City of Richmond Department of Planning & Development Review

LOCATION: 17th Street Farmer's Market

PROPOSAL: Final review of modifications to approved final plans for improvements to the 17th St Farmer's Market

Resubmission of the 17th St. Market Plaza Renovations for February 2017 UDC Meeting:

DRAWING NO.
L201

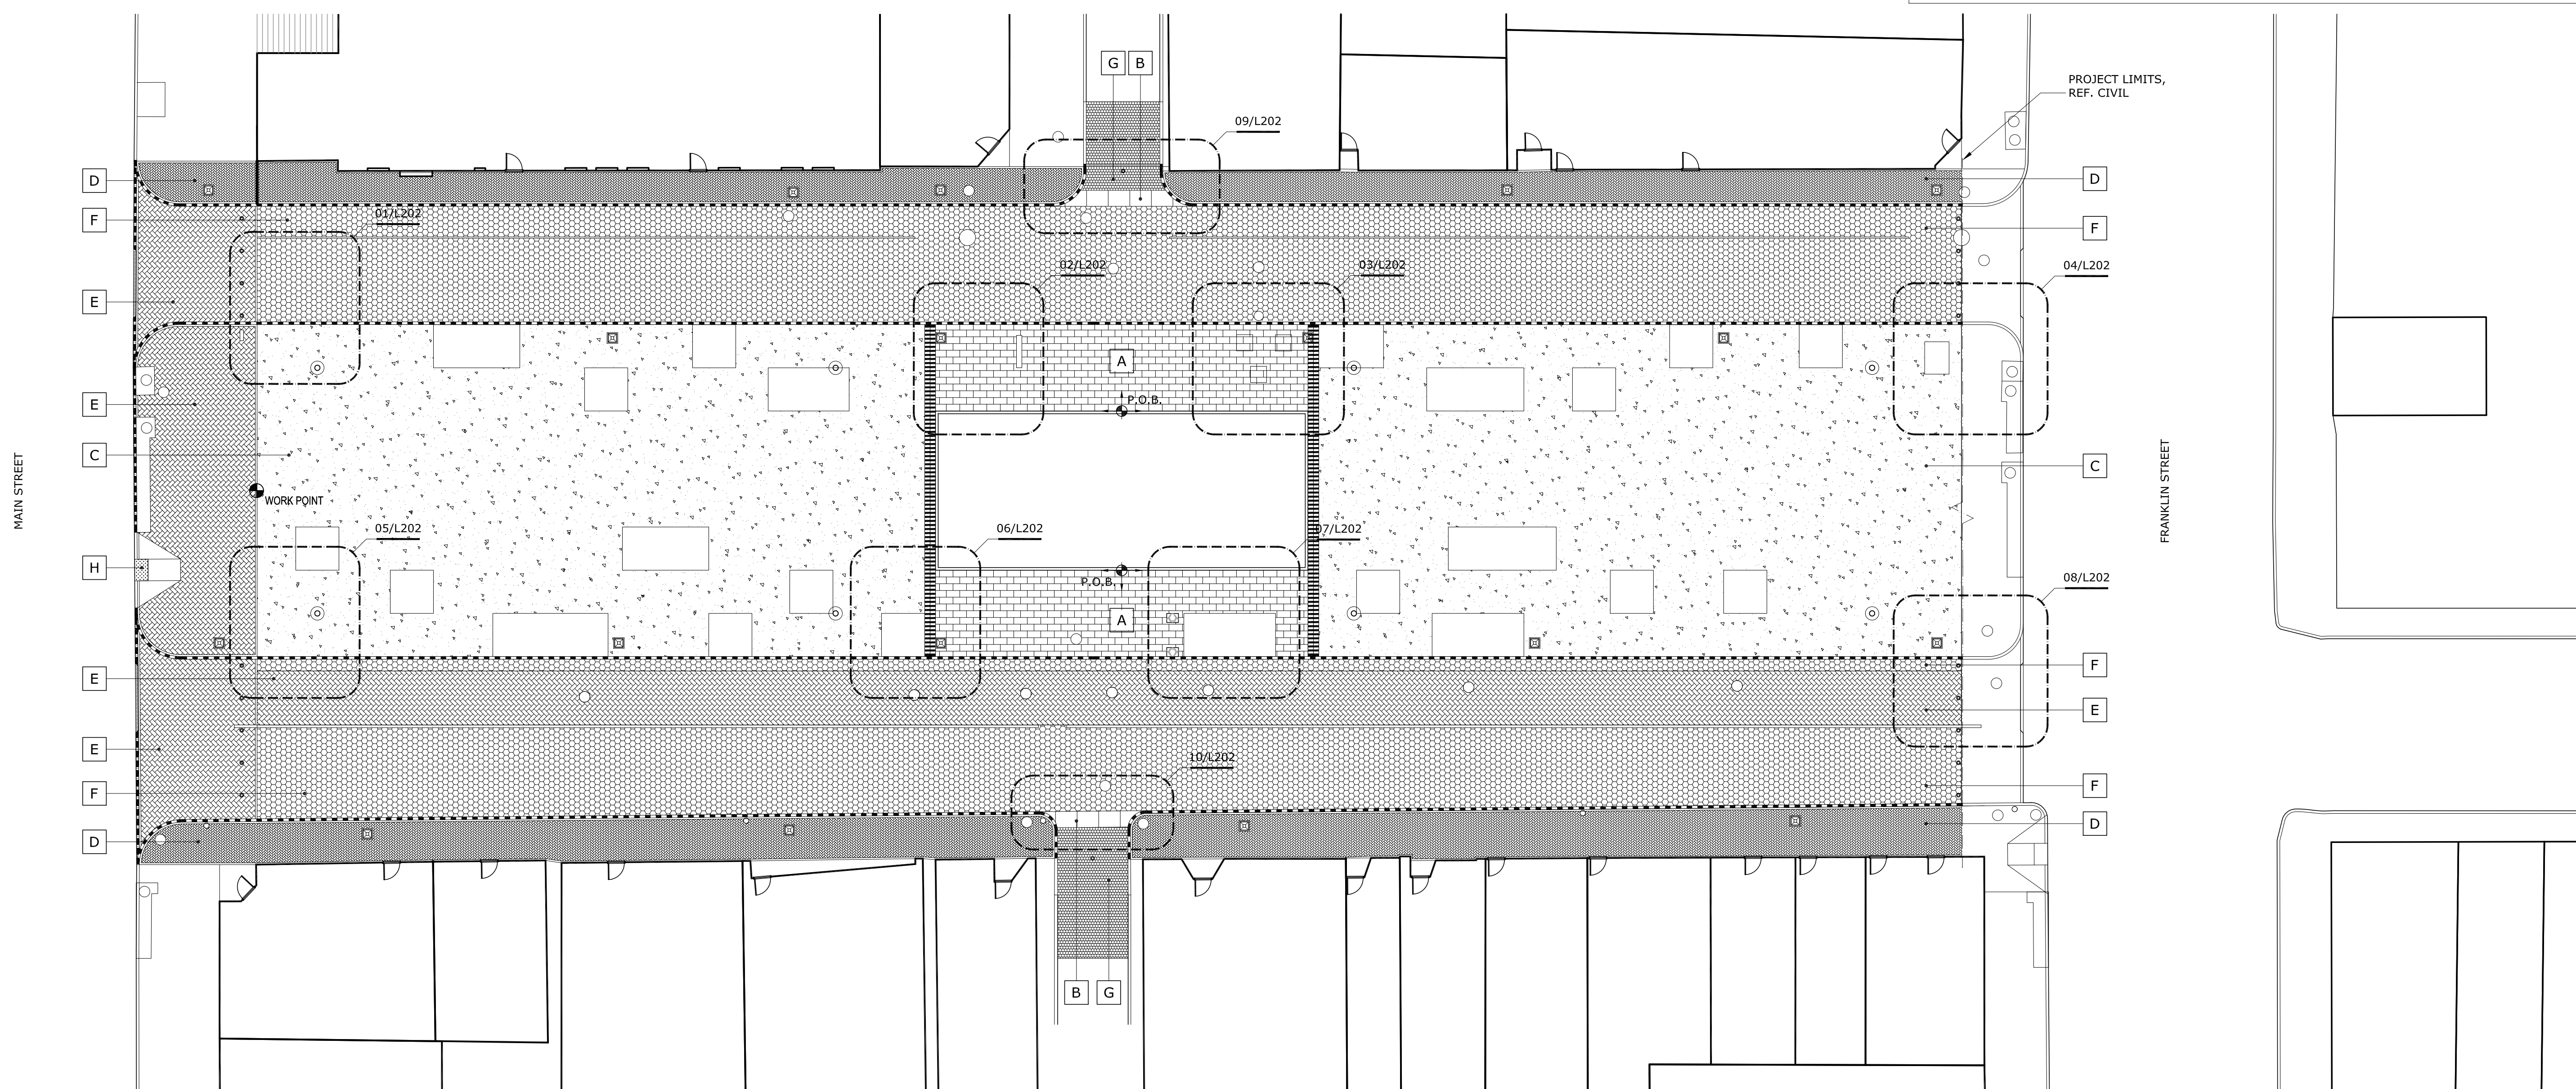
1. Removal of the granite banding/cart paths, introduce brick band/bikeway:

The cost of the constructability of the cobblestone streets, curbing and cobblestone restoration (the granite cart paths have been removed allowing less costly installation of the pavers, reducing the fields from 6 bands of cobblestones, to two bands of cobblestones. This will also insure that the cobblestones are set in arcs, not linear rows. It is very difficult to achieve the arc pattern of the existing durex pavers when the masons must lay them in three separate fields/north to south bands of cobblestones on each street. We believe this is an improvement in the design as well as a cost reduction).

Change “bike lane” from granite to brick pavers in 17th St. northbound (easternmost 17th St. in front of Sweet Teas and LuLu’s)

2. Change granite curbs to granite pavers (same dimensions on the top plane)

The reset granite curb line is expensive and often an abandoned detail. Contractors typically buy new granite curb in lieu of resetting odd formations of existing curbing to achieve the same result. In the case of the redesign of the 17th St. Market Square, the curb line has been changed from deep curbing to shallow granite pavers that from the top plane will read as the original curb line. The “curb” has been eliminated in regards to functionality. Drainage is achieved through trench drains in the center field of the road. Since the granite bands are not visible on their side elevations and the new Plaza is “flush” – the curbs were changed to bands.

3. Change plaza material from granite (poured granite) pavers to concrete with oak leaf imprinted into the concrete field.

The cost of the pavement proposed for the internal 17th St. Market Square (changed from poured granite pavers to brushed concrete with oak leaf imprints at the base of the 22 trees)

4. **Granite (poured granite) field surrounds SOD in the drawings.** SOD is a placeholder for the original Fountain. Fountain to be installed as originally shown (request confirmation from Tim Hamnett, Baskervill Architects).
